**CITY OF SNELLVILLE
DEPARTMENT OF PLANNING & DEVELOPMENT
MAYOR AND COUNCIL**

CASE NUMBER: RZ 19-02 LUP 19-01

DEVELOPMENT/PROJECT: **257-Lot Age-Restricted Single-Family Detached Subdivision**

ZONING PLAN FOR SUMMIT CHASE OVERALL SITE PLAN

The proposed site plan, submitted by the applicant.

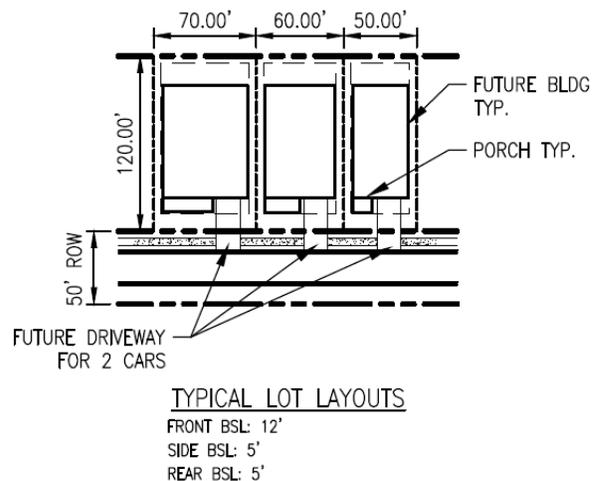
The proposed development is essentially split into two sections by Rosebud Road, with Lots 1-105 on the eastern side of Rosebud Road, just north of Temple Johnson Road and to the west of Brushy Fork Road, where holes 3-6 currently exist; and Lots 106-257 on the western side of Rosebud Road, just north of Temple Johnson Road, where holes 1-2 and 7-9 currently exist. There are two entrances along Rosebud Road, which will be aligned, and will both be gated or have a guard house. The applicant intends to keep the existing golf cart tunnel under Rosebud Road to allow residents access from one side of the development to the other.

There is a large amenity and open space area depicted in the central west portion of the property, though the site plan does not specify what kind of amenities will be located there or the proposed layout. There is also a greyed out 5.70± acre portion of the property on the southwest corner labeled “Future Phase” indicating plans for the potential expansion of the development for Lots 258-280. This “Future Phase” area is not part of this rezoning or land use plan amendment request and will require a separate application submittal and public hearing approval.

Although no structures are shown on the plan, it appears the lot layout, open space and detention pond locations comply with the seventy-five foot (75') buffer requirement of the City’s Stream Buffer Protection Ordinance along the stream bank in the northwest corner of the property.

The applicant is proposing three (3) typical lots layouts, all one-hundred-twenty feet (120') in depth but varying in width from fifty-sixty-seven feet (50'-60'-70'), respectively.

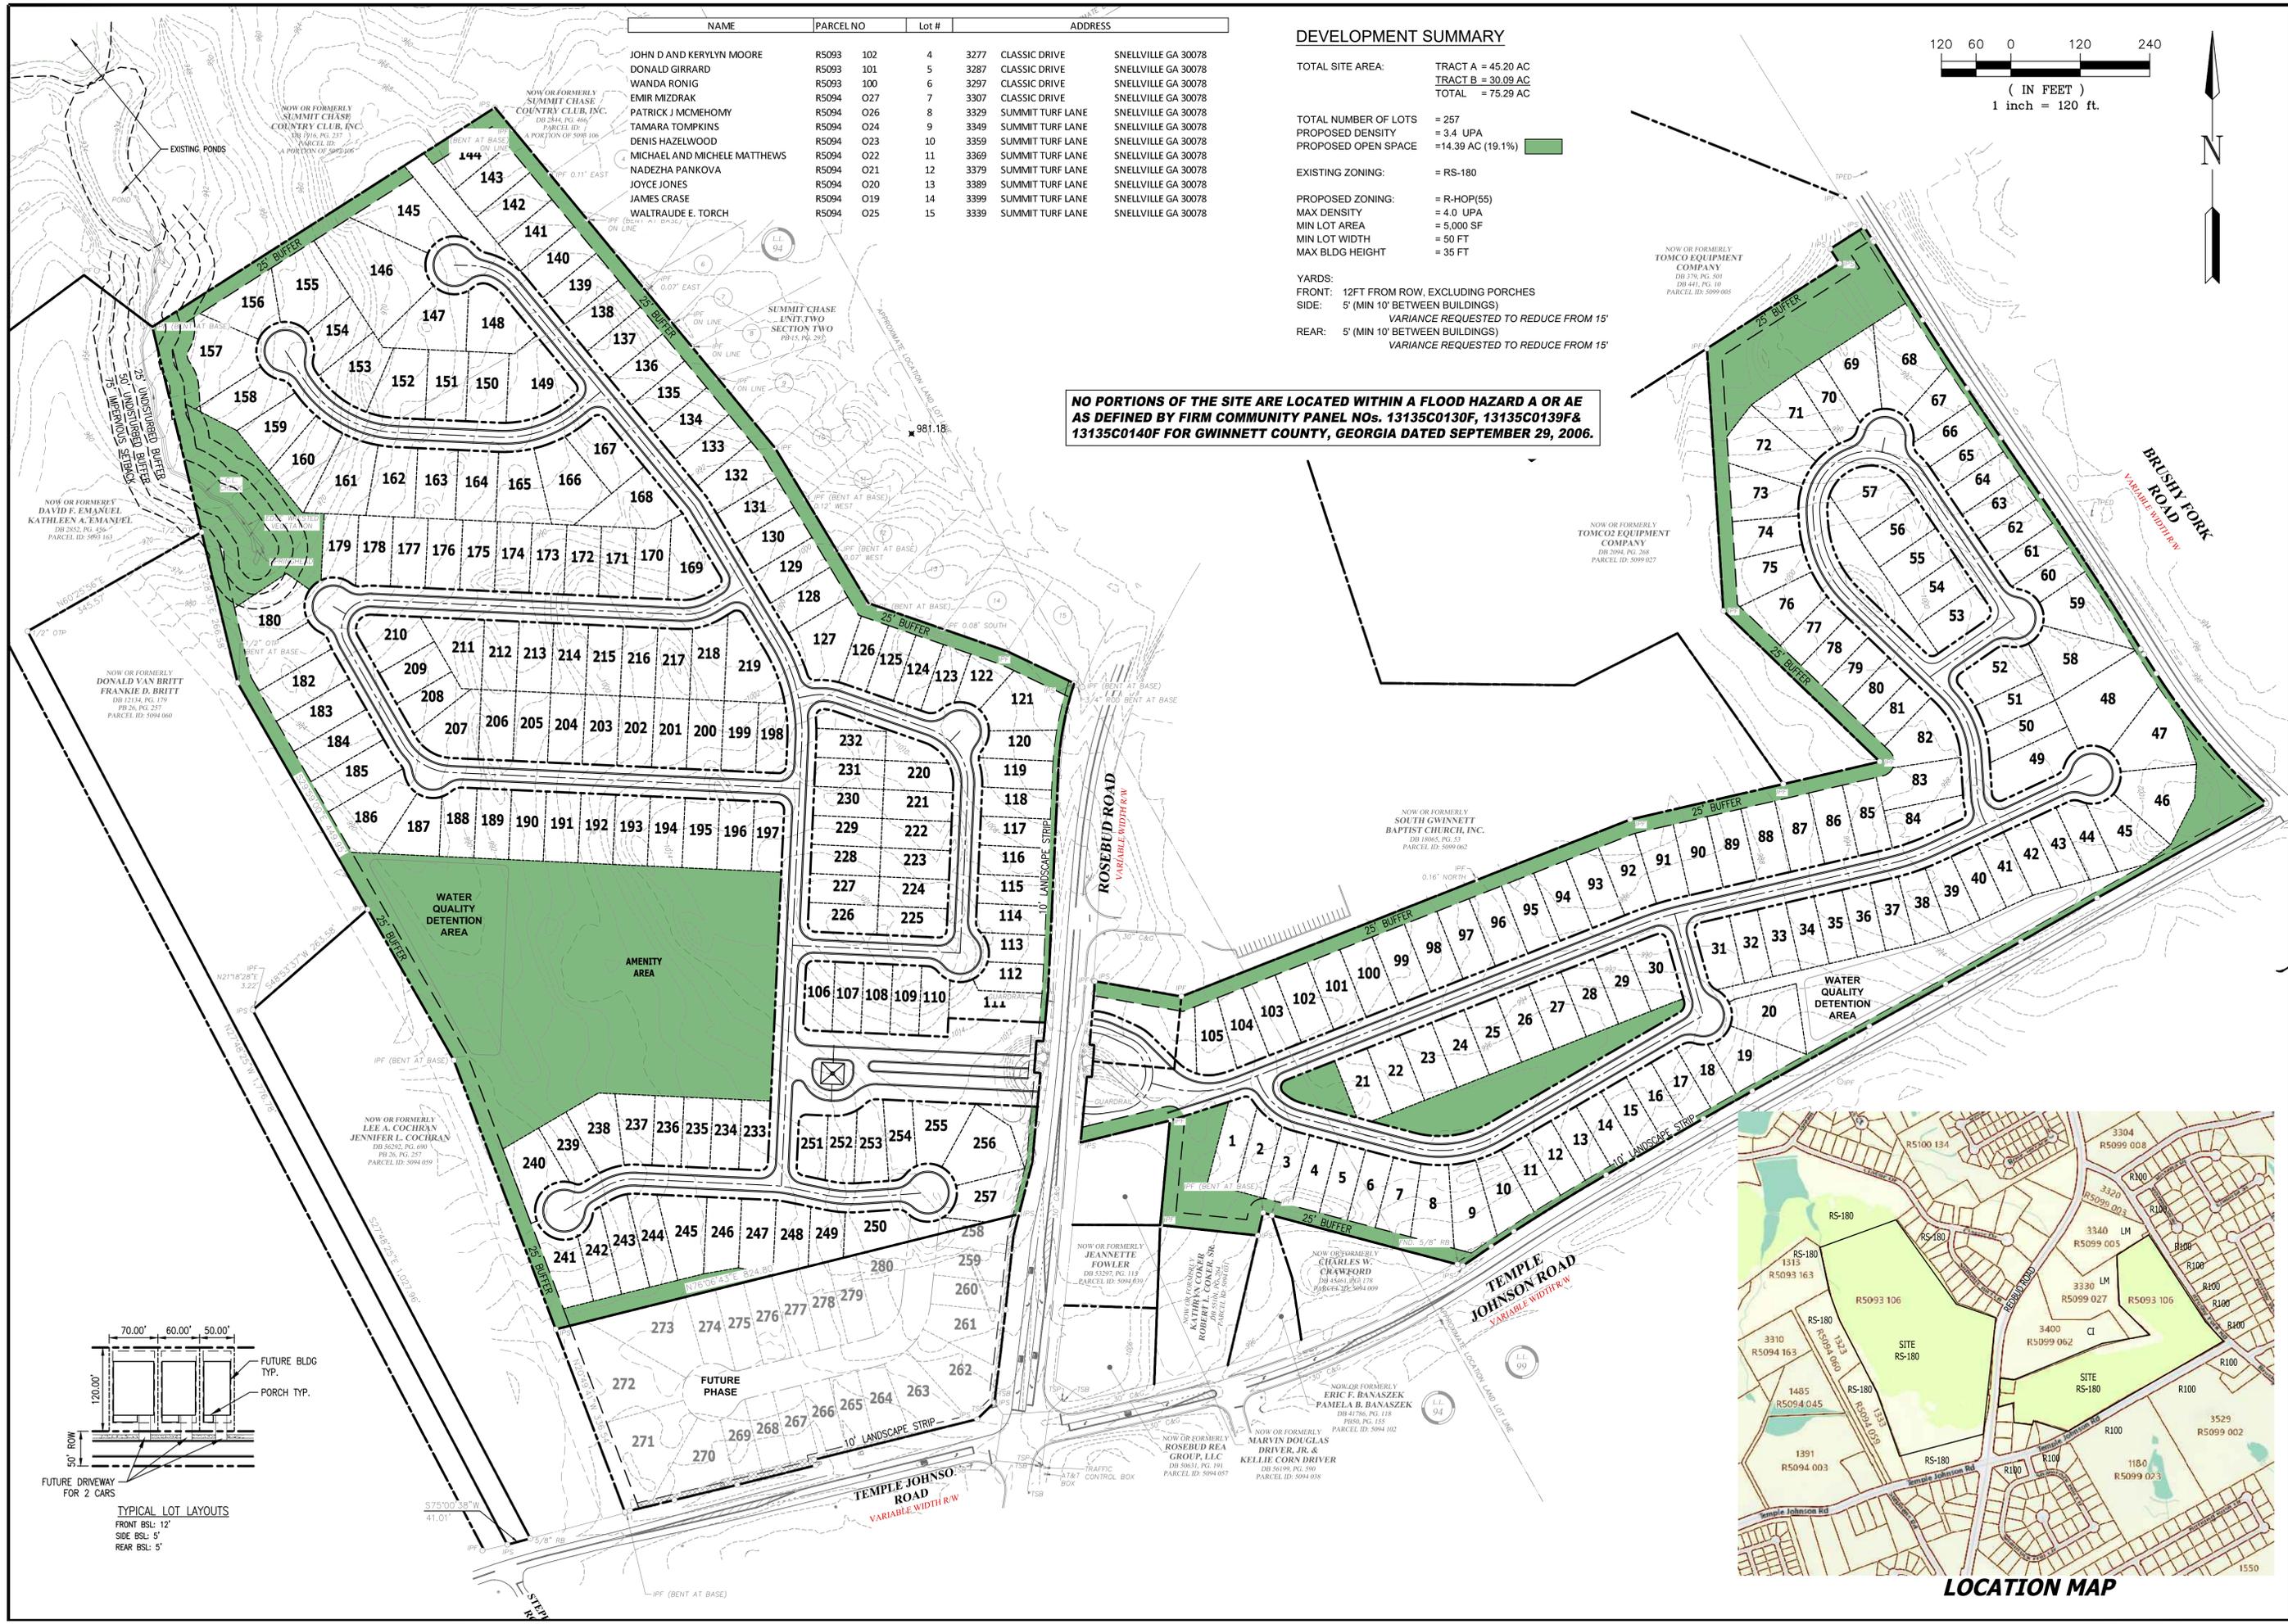
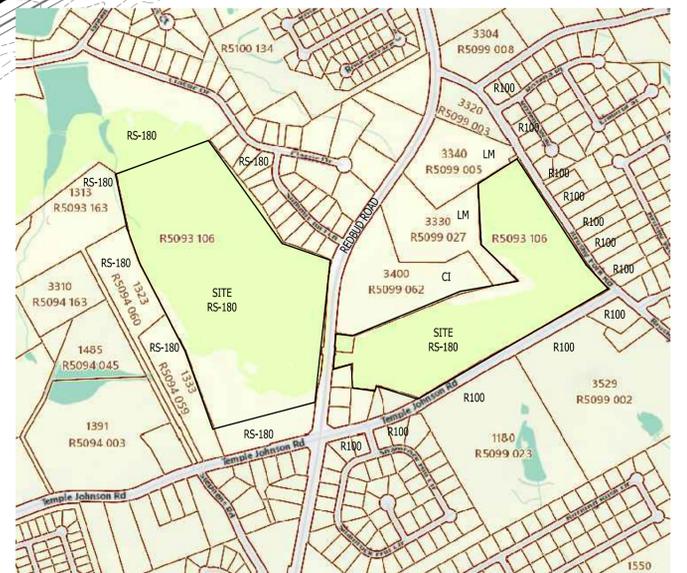
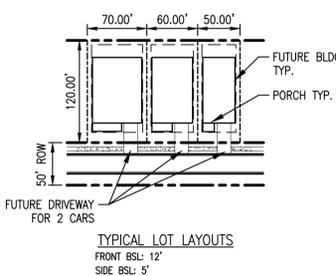
1. Variance from Section 9.19, R-HOP(55)-SF District: Minimum side yard building setback of five-feet (5'), with a minimum of at least fifteen-feet (15') feet between buildings.

Request to allow a minimum building separation of ten-feet (10') between buildings, measured at the foundation.

YARDS:
FRONT: 12FT FROM ROW, EXCLUDING PORCHES
SIDE: 5' (MIN 10' BETWEEN BUILDINGS)
REAR: 5' (MIN 10' BETWEEN BUILDINGS)

VARIANCE REQUESTED TO REDUCE FROM 15'
VARIANCE REQUESTED TO REDUCE FROM 15'

1. Section 9.19, R-HOP (55) SF District: To reduce the minimum separation distance between buildings from fifteen-feet (15’) to ten-feet (10’), measured at the foundation.

1. The property shall be developed in accordance with the rezoning site plan entitled "Summit Chase Overall Site Plan", dated 3-1-2019 (stamped received 3-22-2019), attached hereto as Exhibit "A" and incorporated herein by reference, with modifications permitted due to engineering restrains, ingress and egress, and/or to meet conditions of zoning or State, County, and City regulations. Substantial variation from the rezoning site plan, as determined by the Director of Planning and Development will require Mayor and Council approval;
